# Access Compliance Report

## Public Rights-of-Way

### (Curb Ramps)

Intersection ID: N/A	Main Street: ROCK_ISLAND_RD	Cross Street: AGNEW_DR	Location: SW
ADA ID: 60F0361B0899	Ramp Type: Perp	Initial Pass/Fail: Fail	Overall Compliance: No
Severity Score: 1.25			
Codes/Mitigation Info/Possible Solution		Field Measurements/Component Compliance

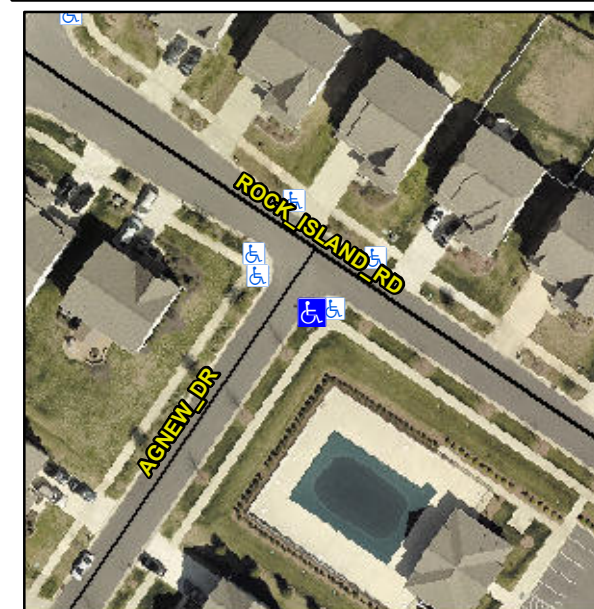
**Not Found, R304.5.3**

Compliance	Description	Data	Compliance	Description	Data
N/A	Ramp Length (in)	126.0	Yes	Ramp Slope (%)	7.6
Yes	Ramp Width (in)	48.0	No	Ramp XSlope (%)	2.9
N/A	Flare Type LT	N/A	N/A	Flare Type RT	N/A
N/A	Flare Slope LT (%)	N/A	N/A	Flare Slope RT (%)	N/A
N/A	Flare Traversable LT?	N/A	N/A	Flare Traversable RT?	N/A
N/A	Landing Length (in)	N/A	N/A	DWS Provided?	N/A
N/A	Landing Width (in)	N/A	N/A	DWS Contrast?	N/A
N/A	Landing Slope (%)	N/A	N/A	DWS Length (in)	N/A
N/A	Landing X Slope (%)	N/A	N/A	DWS Full Width?	N/A
N/A	Landing Curb? (Y/N)	N/A	N/A	DWS Offset (in)	N/A
N/A	Shared Landing?	N/A			
N/A	Gutter Ponding?	N/A	N/A	Gutter Slope (%)	N/A
N/A	Gutter Lip Ht (in)	N/A	N/A	Gutter X Slope (%)	N/A
N/A	Painted X Walk1?	No	N/A	Painted X Walk2?	N/A
	X Walk 1 Direction	To NW		X Walk 2 Direction	N/A
N/A	X Walk 1 Width (in)	N/A	N/A	X Walk 2 Width (in)	N/A
	X Walk 1 Slope (%)	3.8		X Walk 2 Slope (%)	N/A
	X Walk 1 X Slope (%)	0.1		X Walk 2 X Slope (%)	N/A

**Remove & Replace Entire Ramp.**
